# Access Compliance Report

## Public Rights-of-Way

### (Curb Ramps)

Intersection ID: N/A	Main Street: MILLENNIUM_AV	Cross Street: CITY_PARK_DR	Location: SW
ADA ID: F31CDDDBFD2B7	Ramp Type: Directional1	Initial Pass/Fail: Fail	Overall Compliance: No
		Severity Score: 12.5

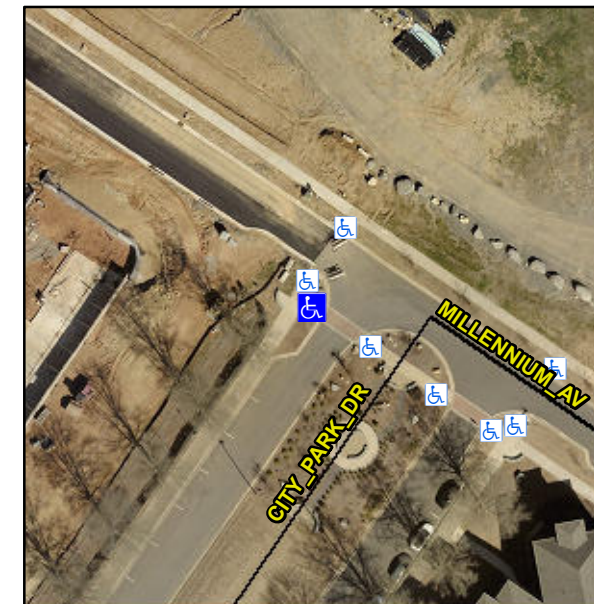
**R304.2.2**

Compliance	Description	Data	Compliance	Description	Data
N/A	Ramp Length (in)	91.0	N/A	Grade Break?	N/A
Yes	Ramp Width (in)	70.0	N/A	Grade Break Slope (%)	0.0
No	Ramp Slope (%)	9.7	N/A	Grade Break XSlope (%)	0.0
Yes	Ramp XSlope (%)	0.0			
N/A	Flare Type LT	N/A	N/A	Flare Type RT	N/A
N/A	Flare Slope LT (%)	N/A	N/A	Flare Slope RT (%)	0.0
N/A	Flare Traversable LT?	N/A	N/A	Flare Traversable RT?	N/A
N/A	Landing Length (in)	0.0	N/A	DWS Provided?	N/A
N/A	Landing Width (in)	0.0	N/A	DWS Contrast?	N/A
N/A	Landing Slope (%)	0.0	N/A	DWS Length (in)	N/A
N/A	Landing X Slope (%)	0.0	N/A	DWS Full Width?	N/A
N/A	Landing Curb? (Y/N)	N/A	N/A	DWS Offset LT (in)	N/A
N/A	Shared Landing?	N/A	N/A	DWS Offset RT (in)	N/A
N/A	Gutter Ponding?	0.0	N/A	Gutter Slope (%)	N/A
N/A	Gutter Lip Ht (in)	0.0	N/A	Gutter X Slope (%)	N/A
N/A	Painted X Walk1?	Yes		Road Slope (%)	1.9
	X Walk 1 Direction	To SE		Road X Slope (%)	1.7
	X Walk 1 Width (in)	84.0		Clear Space?	N/A

**Remove & Replace Entire Ramp.**
